ITEM NUMBER	6.1
SUBJECT	Gateway request – Planning Proposal – 18 – 40 Anderson Street, Parramatta
REFERENCE	RZ/4/2018 - D06537300
REPORT OF	Project Officer- Land Use Planning
LAND OWNER:	Australia and New Zealand International Investment Group Pty Ltd
APPLICANT:	Landream

To seek the Local Planning Panel's (LPP) endorsement of a Planning Proposal at 18 – 40 Anderson Street for the purposes of seeking a Gateway Determination from the Department of Planning and Environment. The Planning Proposal seeks to:

Figure 9: The proposed design concept. A new park and green link is shown on the southern part of the site

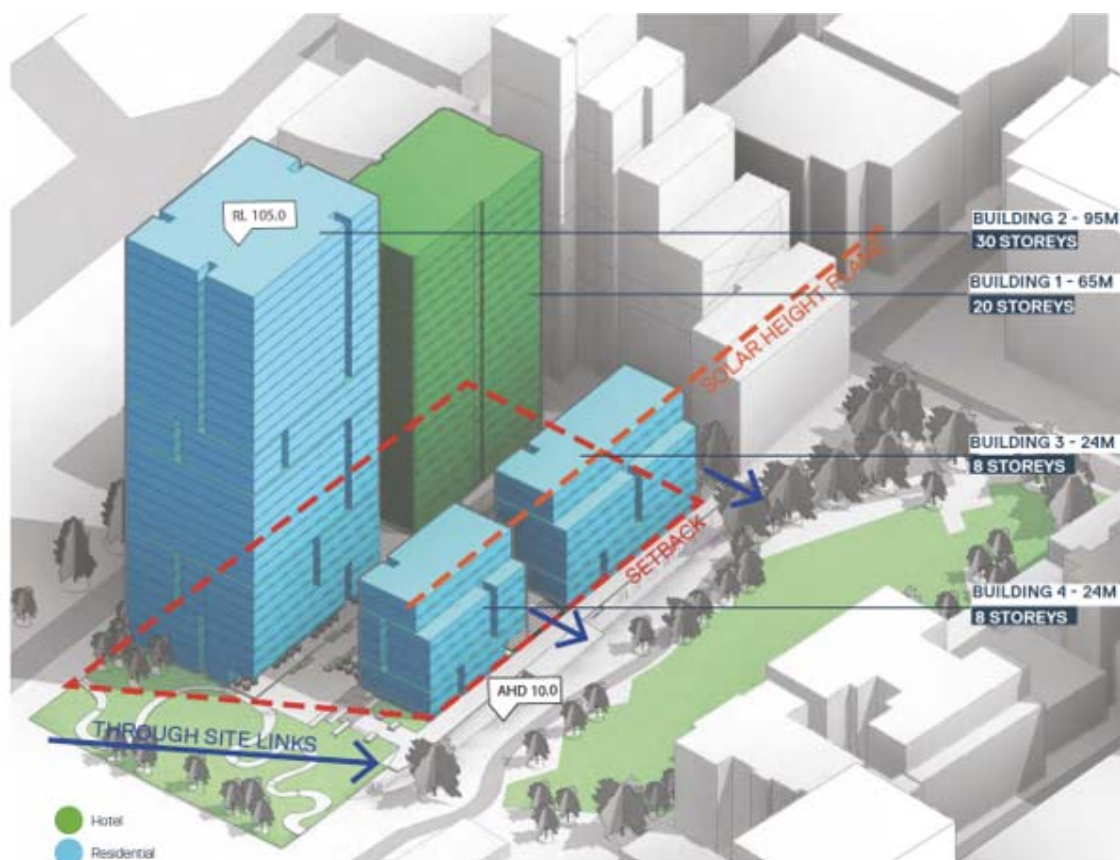
16. The building separation of the proposed towers in the original design is 12 metres (See Figure 9)– two towers have been located with minimal separation to achieve an FSR 6:1 – this is not supported and may not meet Apartment Design Guidelines. A scenario with one taller tower and 6-8 storey street wall buildings around a courtyard will result in improved separation, amenity and views. An alternative scenario with two towers, one up to 120 metres in height and the second tower fronting Anderson Street of a lesser height may also be considered. Preliminary modelling prepared by the Urban Design Team suggest that a 120m tower can be located on site whilst still protecting Jubilee Park from overshadowing. The site-specific provision to be included in the Planning Proposal regarding overshadowing of Jubilee Park will reinforce the solar access protection. The two tower scenario is shown in **Figure 10**

Figure 11: Revised development concept submitted by applicant. Blue represents residential floor space and yellow represents non-residential floor space

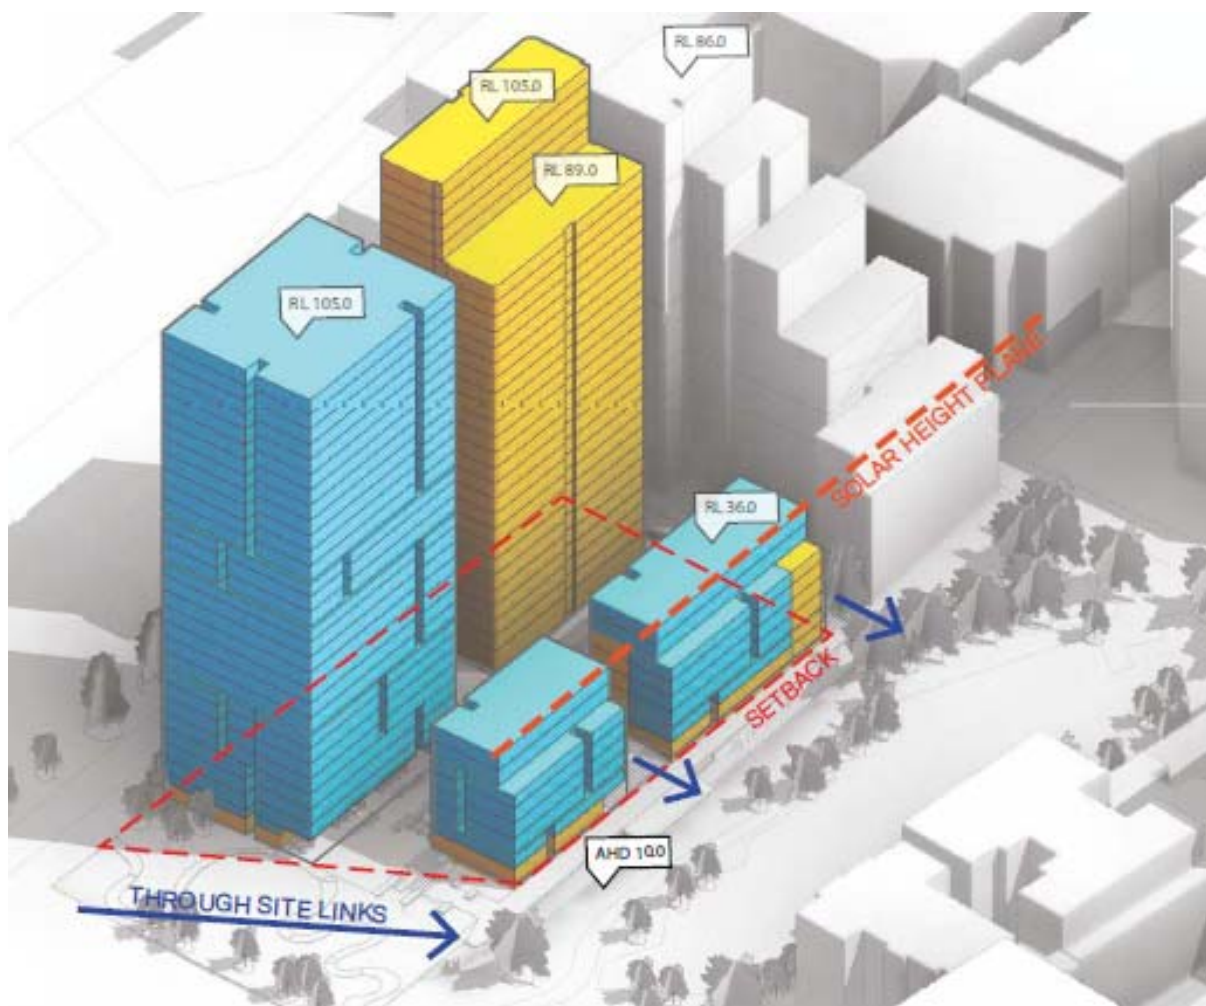
46. Whilst the applicant's proposal requests a building height of 95 metres as shown in Figure 11, urban design testing by City staff recommends a more flexible approach be taken to give more design options at the design excellence stage of the process. The urban design assessment undertaken by Council Officers considers that allowing this additional flexibility will allow for a potentially better urban design outcome on this site with one taller tower surrounded by a series of smaller buildings (refer Figure 10) rather than two towers of equal height in the applicant's reference design. The building height and massing will be subject to the recommended site-specific provision requiring solar access to Jubilee Park and it is considered that a design that allows for a taller tower in the location shown in Figure 10 can be developed in a manner that still has acceptable outcomes in terms of overshadowing of Jubilee Park and other adjoining sites.

Figure 13: Revised flood mitigation and water management proposal

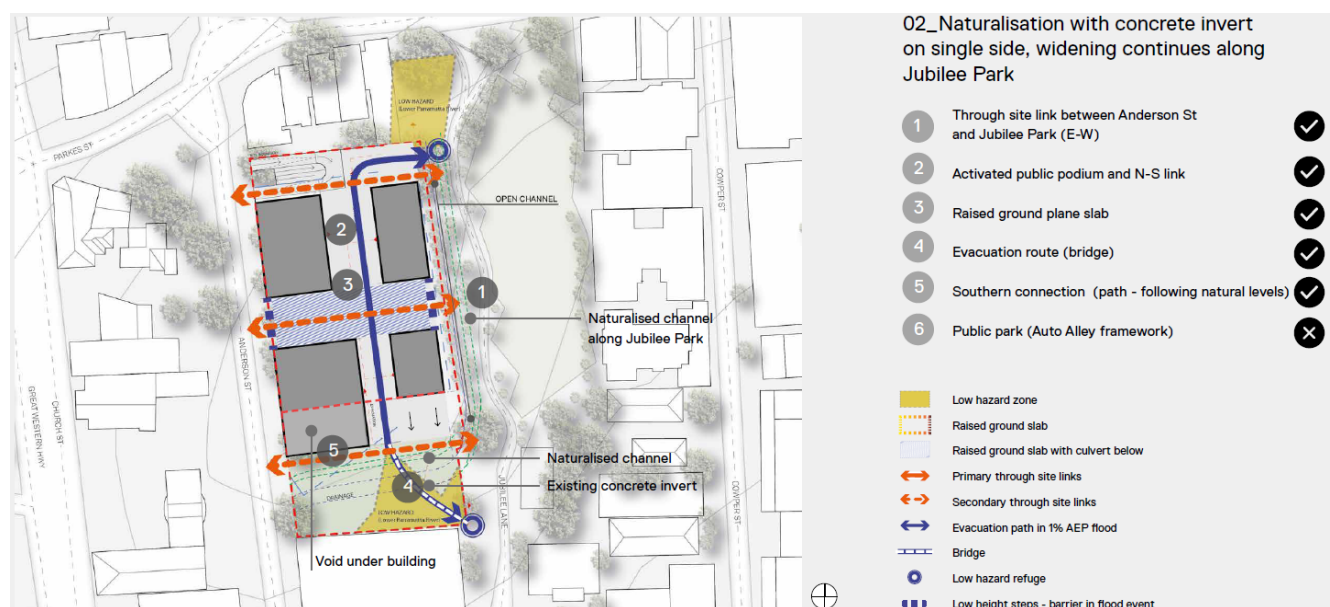
50. City staff considered that in principle the revised concept has the potential to address the flood risk issue in a manner that minimises flood risk to future occupants of the site and the broader community. Nevertheless, there are some concerns about the details of the concept that can be resolved with the progression of the Planning Proposal and a site-specific DCP. The proposal to widen the channel into Jubilee by 1m along its western edge (as shown in Fig 14 above) will increase the risk to park users by providing landscaping that attract people to the high hazard, 100 year/floodway zone. City staff also do not support the benching of Jubilee Park as it will reduce the area of contiguous usable open space. The eastern edge of the channel, alongside Jubilee Park, should remain more or less as it is now. Instead, the channel can be widened and deepened on the western side of the culvert within the applicant's site.
